Outermost Inn Modification DRI 336-M2

Martha's Vineyard Commission
Continued Public Hearing
Feb. 2, 2023

Modification review

Updated parking plan, hand drawn changes

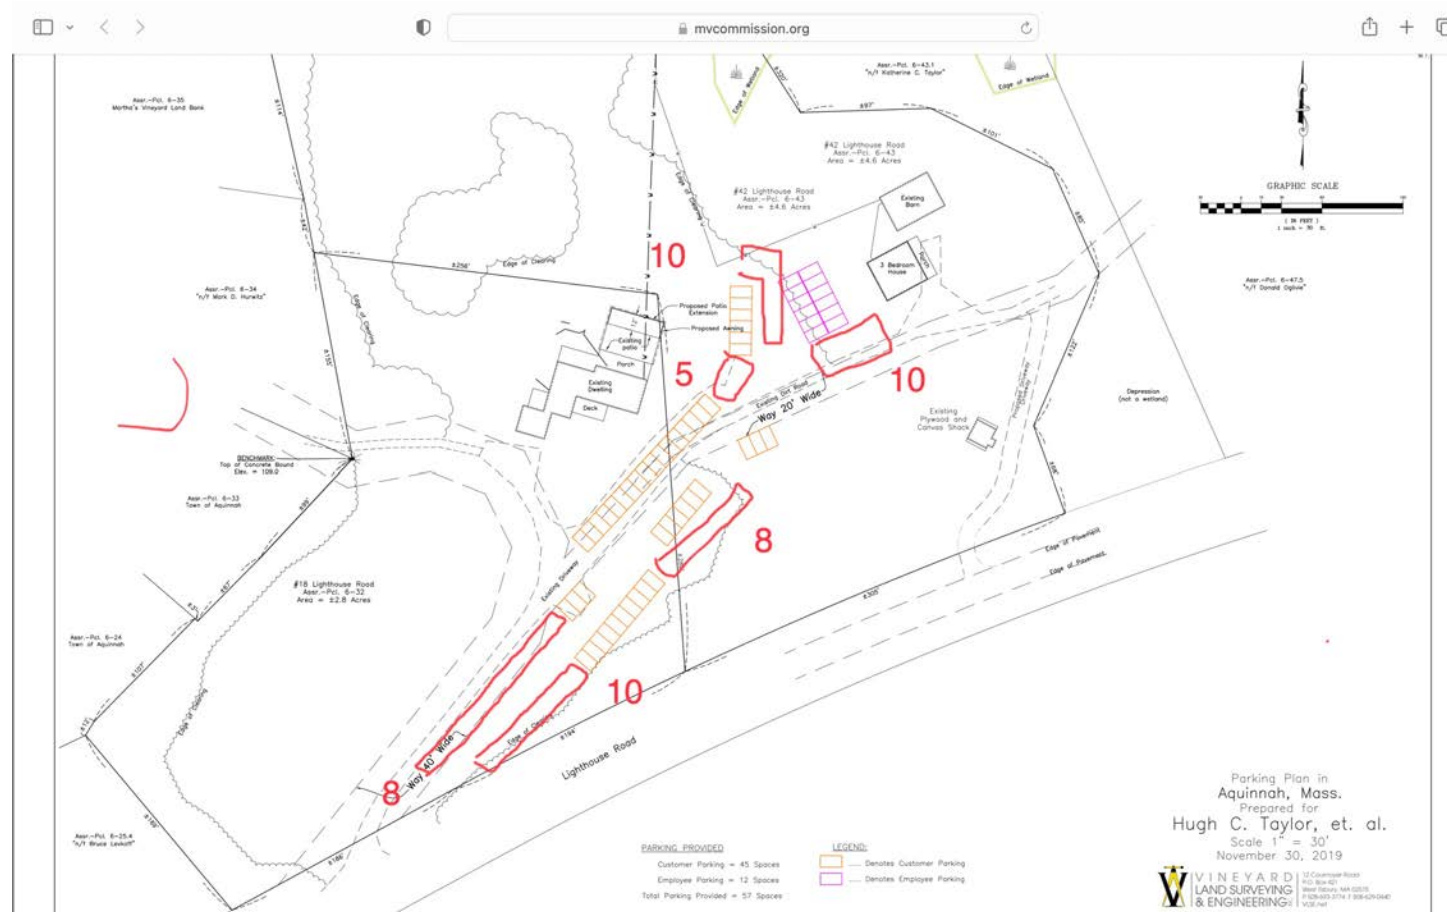
- A parking plan dated 11/30/22 shows a total of 57 parking spaces, including 26 on the Outermost Inn property, and 31 on the abutting property.
- Twelve of the spots are for employee parking on the abutting lot.
- Fourteen of the spots partly coincide with the travel way of an access road that connects properties to the east, although vehicles can still get by. The applicant has clarified that there is alternate access to the lots beyond the parking area.

PROPOSED PARTIAL NORTH ELEVATION

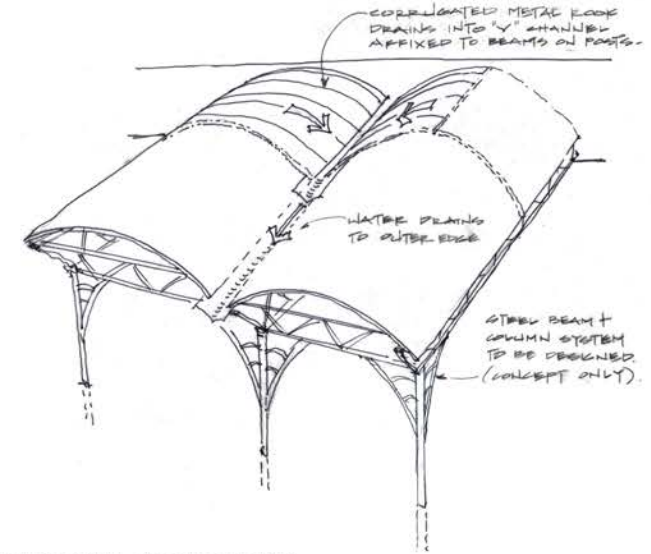
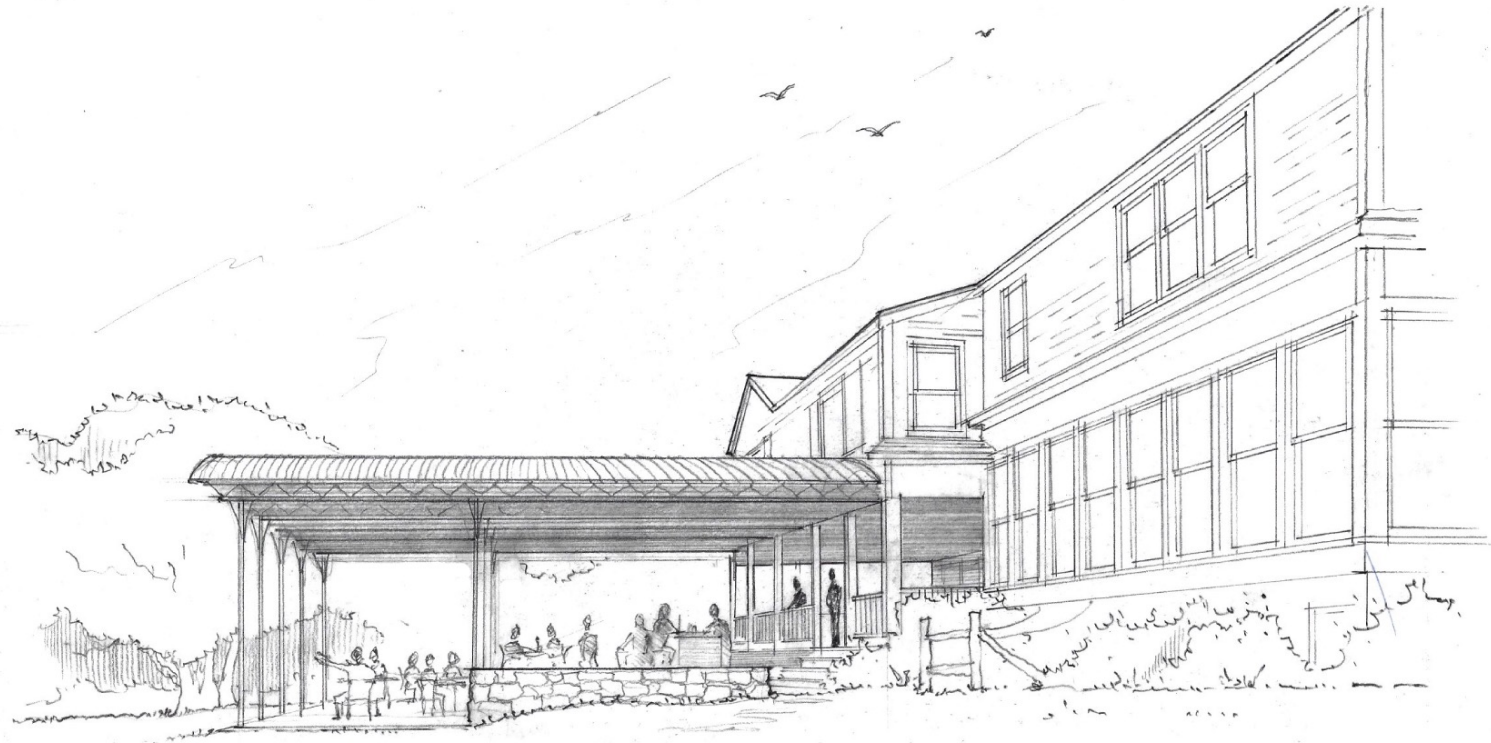
- The proposed structure would be connected to the existing building and would include V-shaped channels in the canopy that direct runoff away from the structure.
- A formal drainage plan is still pending.
- The applicant should clarify the wind rating of the proposed awning structure.
- Final plans for drainage and the awning structure would need to return to LUPC prior to the issuance of building permit
